# Nomad

# SERVICE BULLETIN

## REPLACEMENT OF VHF COMMUNICATIONS ANTENNA (MODIFICATION N368 TO CUSTOMER OPTIONS G73, G73-24, G121, G121-24, G295 AND G295-24).

**NMD-23-3**

Figure 1 Installation of Mod N368

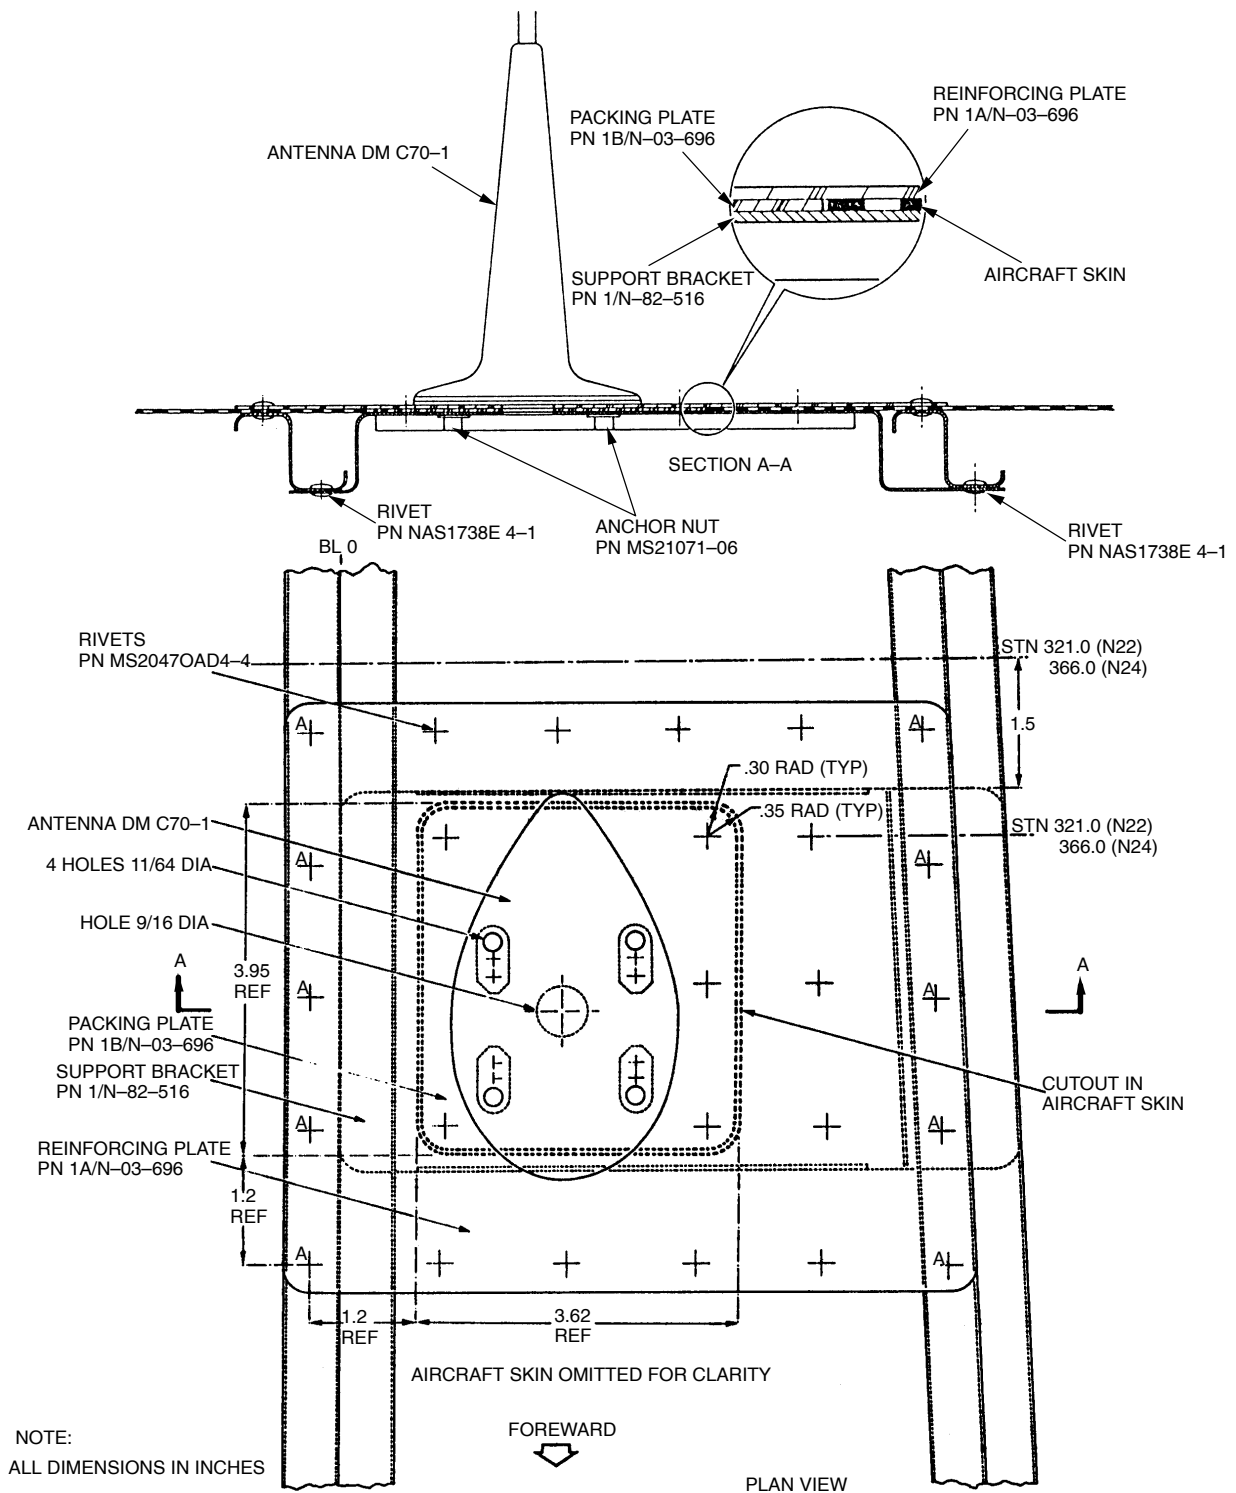
The antenna type AV529 is replaced by type DM C70-1 and a new support bracket provided.

- D. Cut away the section of the aircraft skin as shown in Figure 1 and smooth the edges around the cut out.
- E. Manufacture the new support bracket PN 1/N-82-516 (Ref Figure 2), reinforcing plate PN 1A/N-03-696 and packing plate PN 1B/N-03-696 (Ref Figure 3).

- F. Remove the existing rivets at the positions marked A in Figure 1 and rivet the reinforcing plate PN 1A/N-03-696 to the aircraft skin at the positions marked A. Wet assemble the rivets PN MS20470AD4-4 with pigmented jointing compound.

- K. Fit the support bracket in position shown in Figure 1 and secure to 1 stringers using pop rivets PN NAS1738E4-1. Ensure that the holes in the bracket align with those in the packing plate and reinforcing plate. Use Brisal bonding paste, or equivalent, in the area of the antenna mounting holes and wet assemble the securing rivets with pigmented jointing compound.

Figure 2

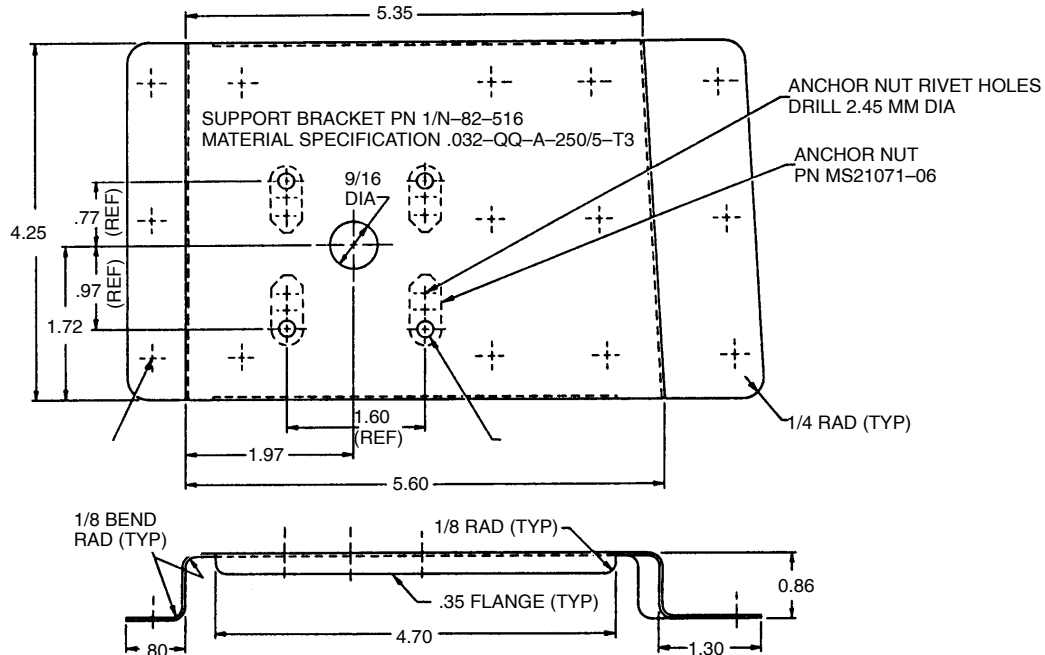
- H. Drill 2.45 mm diameter holes in the new support bracket in positions shown in Figure 2 and secure anchor nuts PN MS21071-06 using rivets PN MS20426AD3-3.
